Amendments to the Drawings:

REMARKS

Appl. No. 10/649,785
 Art Unit 2133
 Customer No. 26694
 Confirmation No. 5599
 Annotated Sheet Showing Changes

Figure 5. Beta Computation Block Diagram

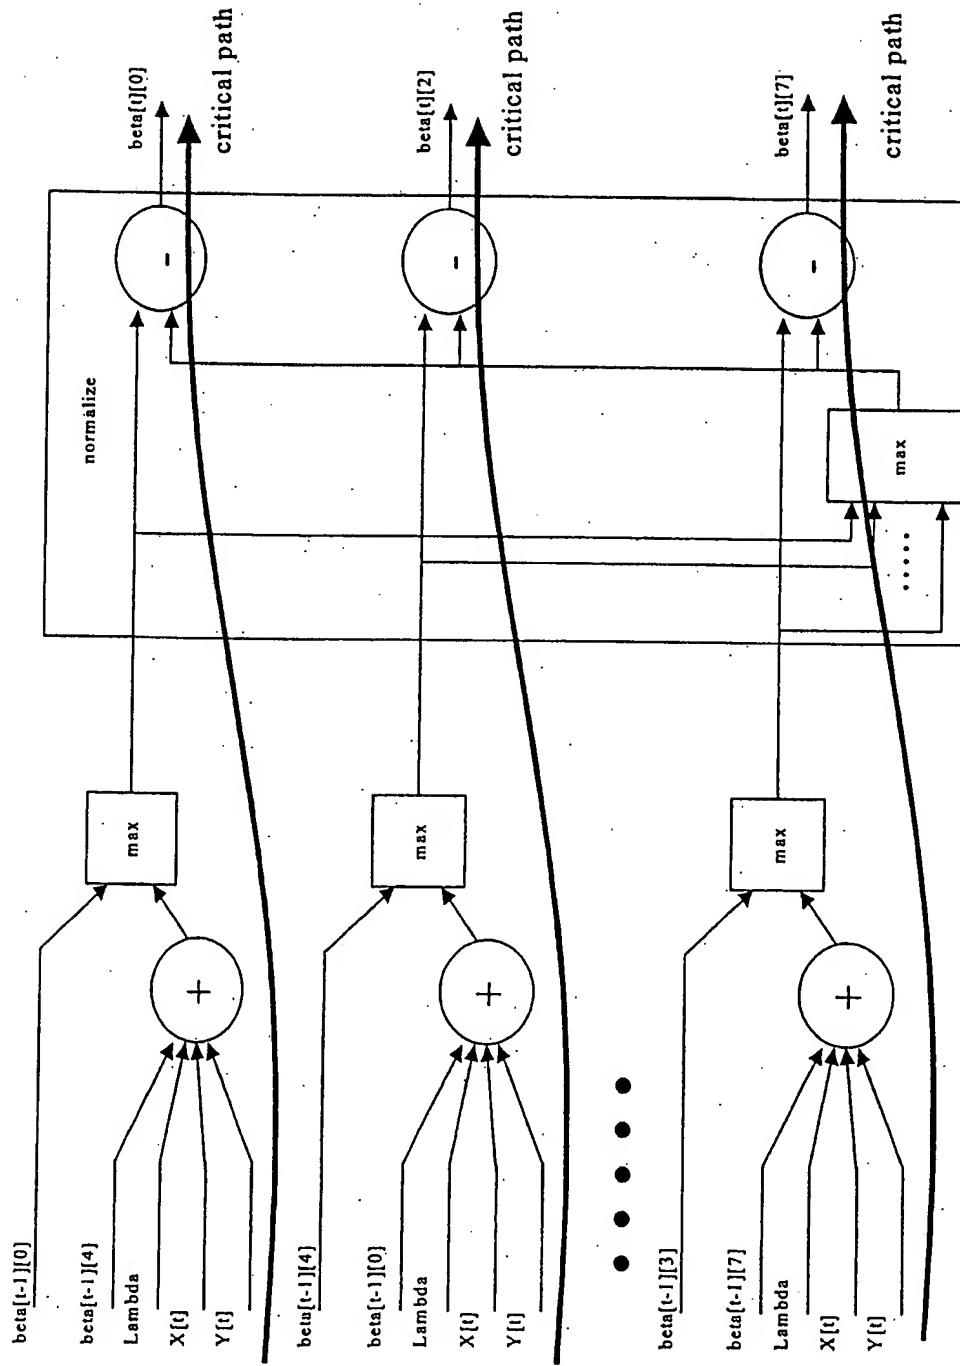
The attached sheets of drawings include changes to Figs. 1-17. The changes to Figs. 1-17 include the addition of the legend "Prior Art" to Figs. 5, 6 and 10-12, and the deletion of PCT headings (e.g. 1/16, 2/16,..., and 16/16) from each of the sixteen sheets of drawings. The replacement drawing sheets submitted herewith replace the originally filed drawings and, to the best of the knowledge of the undersigned, include no new matter.

2. The drawings are objected to because Figs. 5, 6 and 10-12 should allegedly be labeled by a legend such as "Prior Art" in order to clarify Applicants' invention. Applicants have amended Figs. 1-17 by adding the legend "Prior Art" to Figs. 5, 6 and 10-12, and deleting the PCT headings (e.g. 1/16, 2/16,..., and 16/16) from each of the sixteen sheets of drawings. The replacement drawing sheets submitted herewith replace the originally filed drawings and, to the best of the knowledge of the undersigned, include no new matter.

Prior Art
